BRIDGE REPLACEMENT - PPCB

NEW DUAL BRIDGES AS PART OF 4 LANE US 20 PROJECT OVER BOYER RIVER 1.9 MILES WEST OF US 71

REVISION EXAMPLE

NOTICE: This plan revision example is in the MicroStation V8i format of CADD sheets and differs from the MicroStation CONNECT format of CADD sheets. The relevant part of this example to focus on is the use of the revision cloud, crossed out text and details, and the use of the revision triangle.

PIER FOOTING LAYOUT
PILE DIMENSIONS SHOWN ARE AT BOTTOM OF
FOOTING. BATTER PILE 1:4 IN DIRECTION SHOWN.

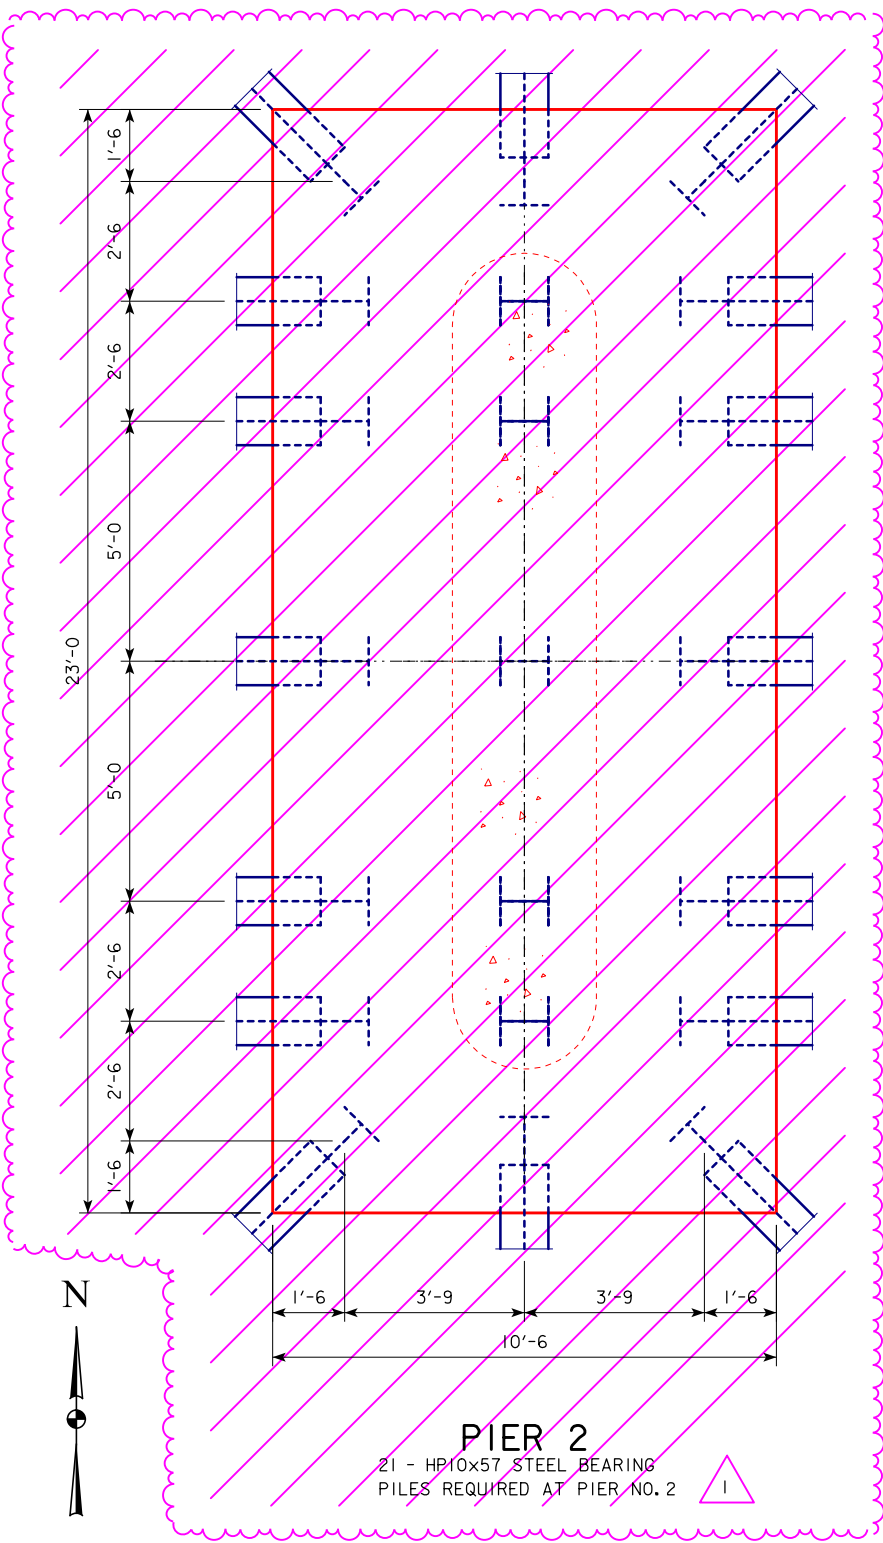
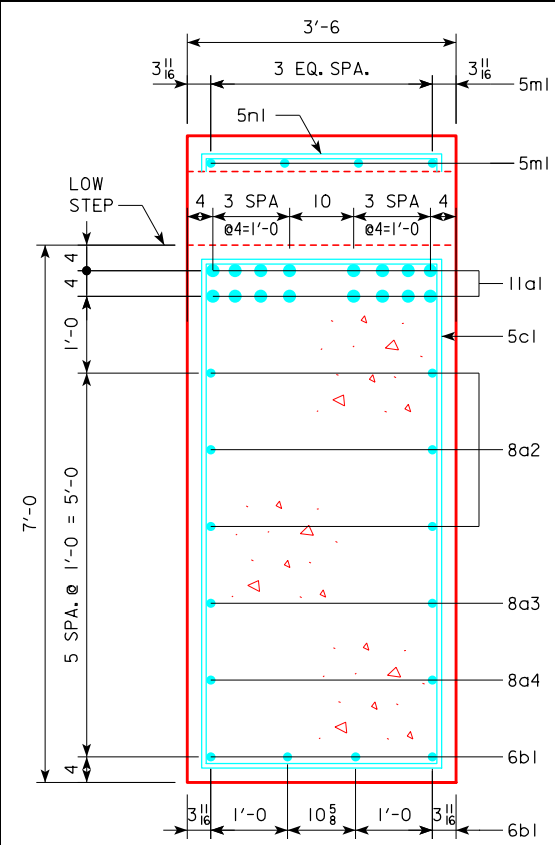
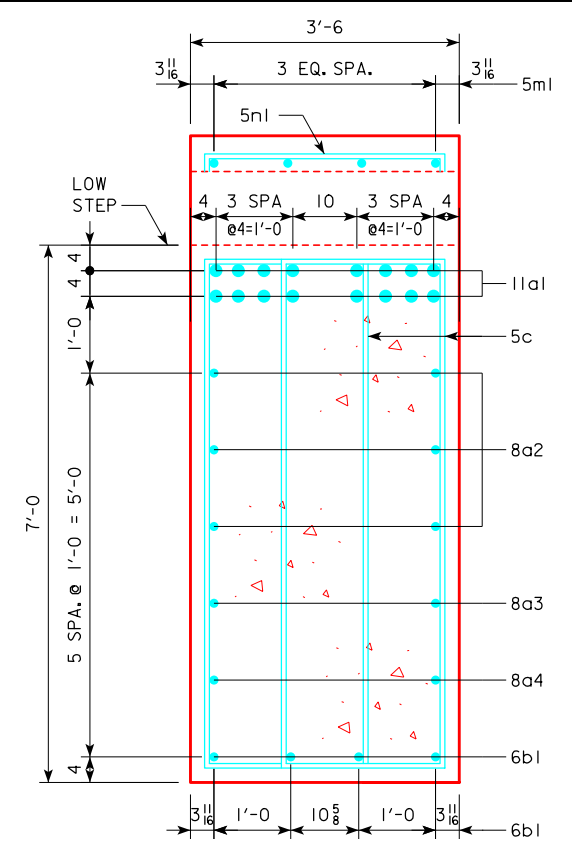
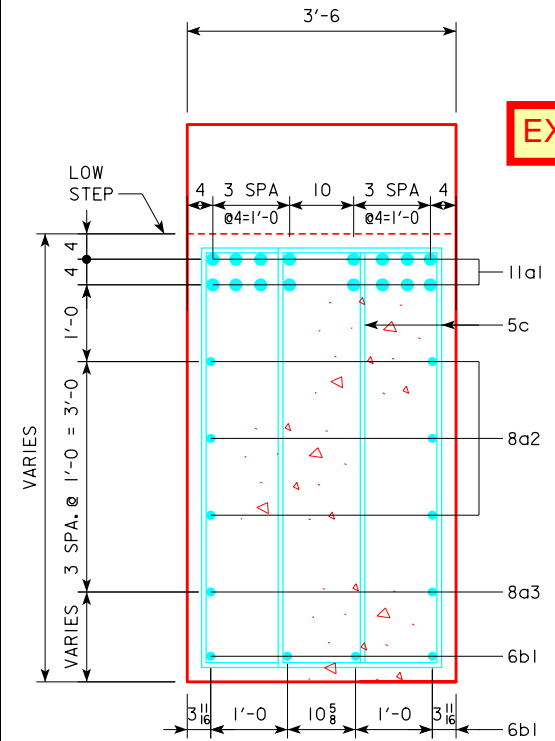
REVISED: 03-09-2017 REMOVE PIER 2 FOOTING.
REASON: PIER 2 FOOTING MISPLACED 1.4 FT. NORTH
OF PLAN ALIGNMENT DUE TO CONSTRUCTION
SURVEY ERROR.

PIER QUANTITIES

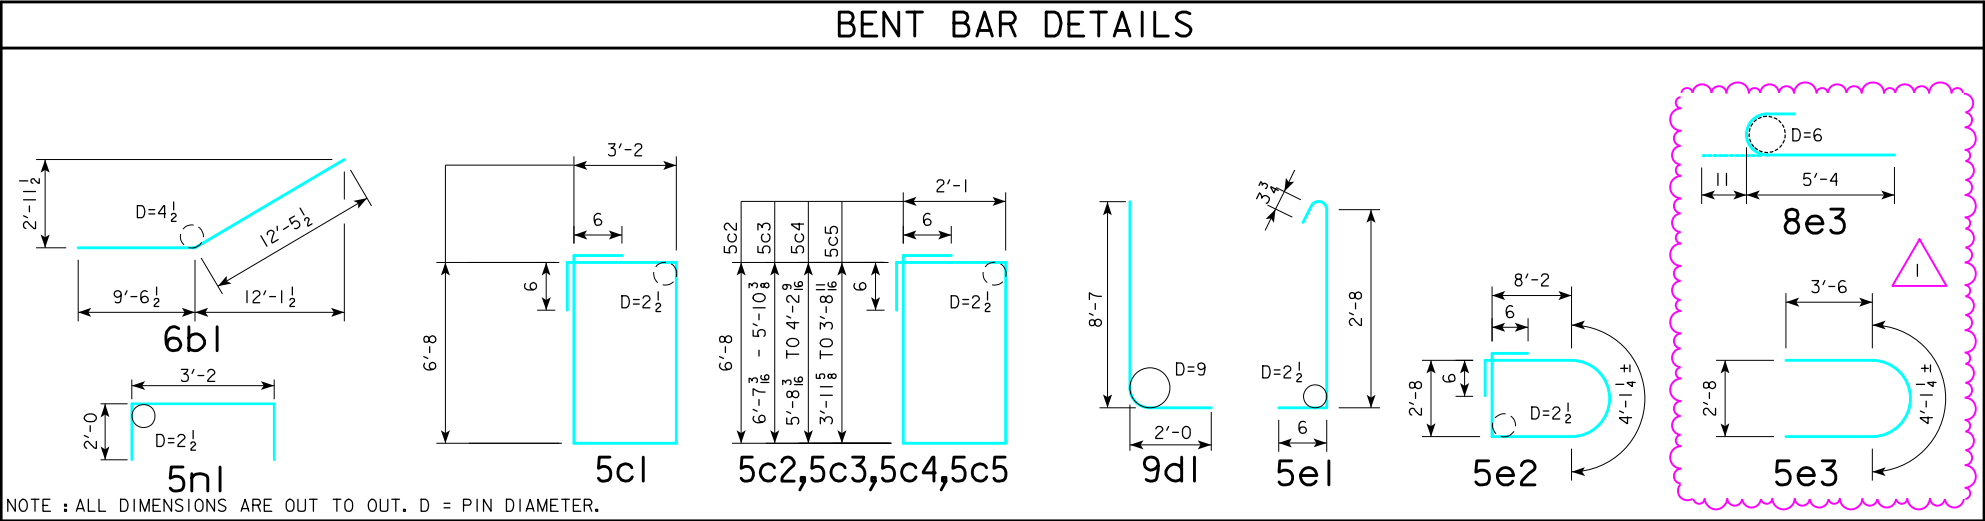
* NOTE:
ADDITIONAL REINFORCING BARS TO BE
PROVIDED FOR WIDENED FOOTING. SEE
DESIGN SHEETS 7C & 7D.

REVISED: 03-09-2017 SEPARATED PIER 1 AND 2
QUANTITIES AND ADDED DOWEL NOTE.

REASON: PIER 2 FOOTING MISPLACED 1.4 FT. NORTH
OF PLAN ALIGNMENT DUE TO CONSTRUCTION
SURVEY ERROR.

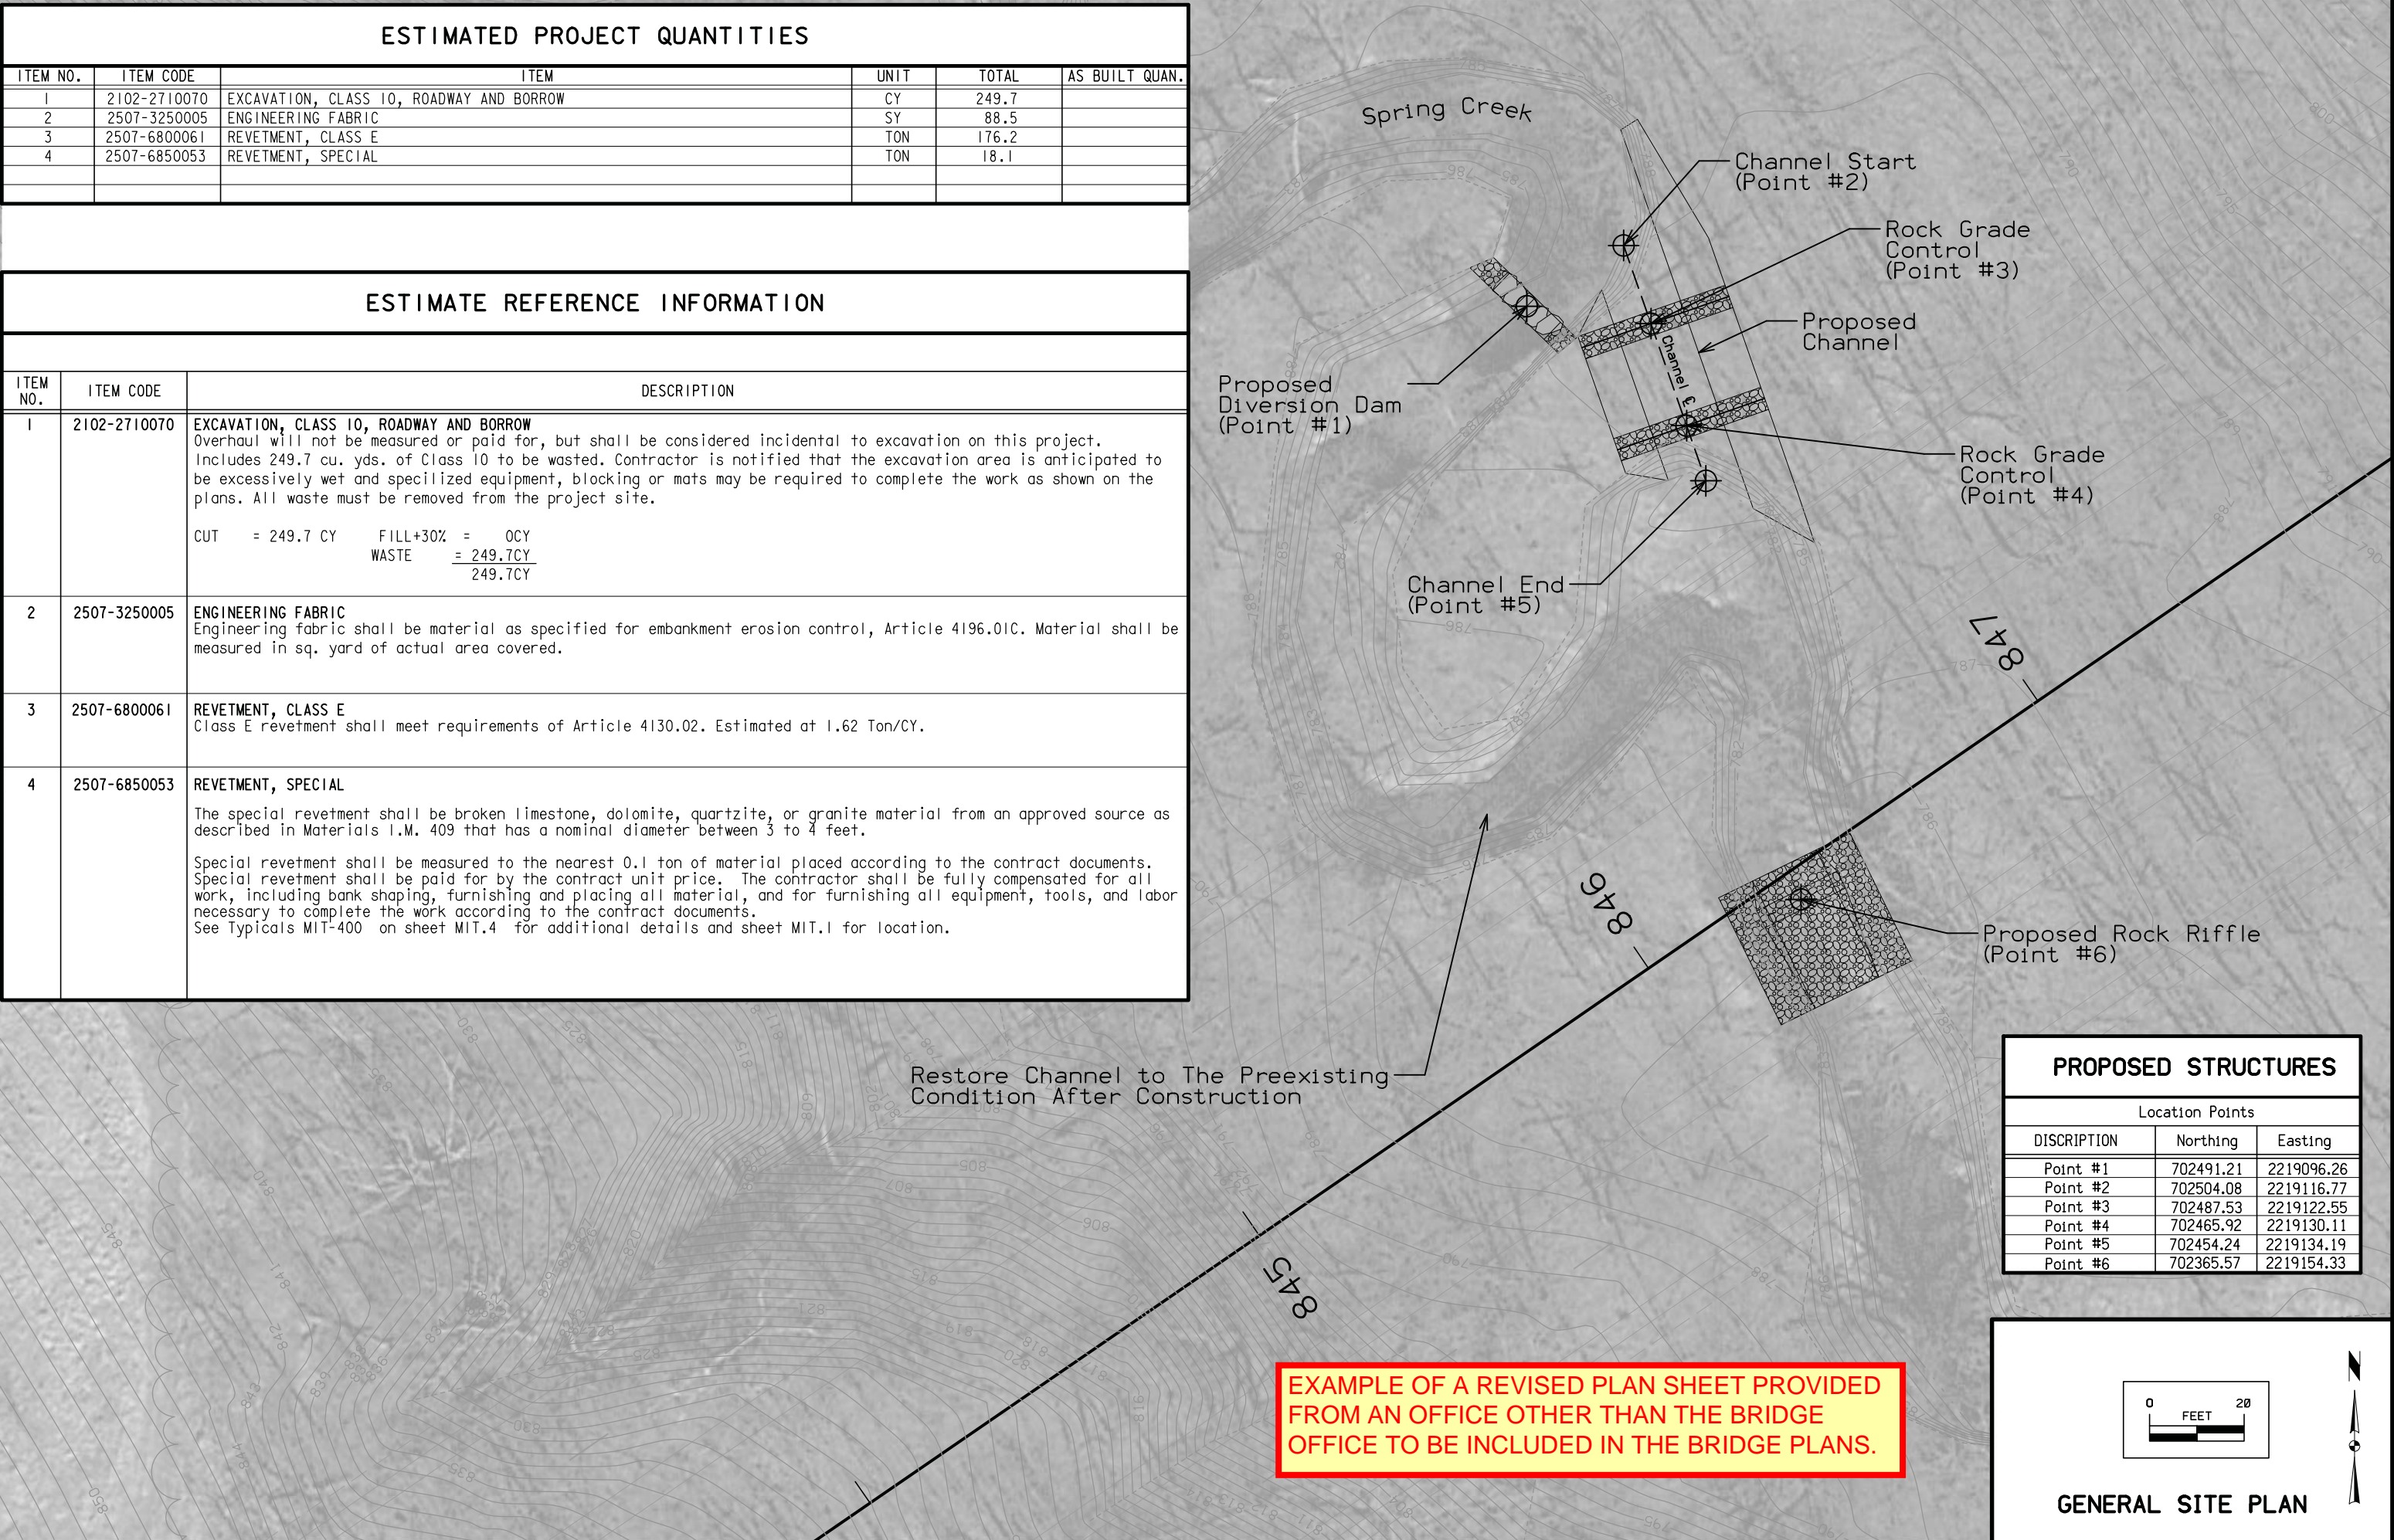
LISTING OF PROJECT REVISIONS			111-23 10-17-17
Date	Sheet No.	Description of Revisions	
11/21/2017	A.1	Added listing of project revisions and signature block for revisions.	
11/21/2017	MIT.1-MIT.4	Add channel straightening design and the stream mitigation required by the revision of the	
		Section 404 Permit #: 2016-1018 in order to accommodate the construction of the bridge pier footing.
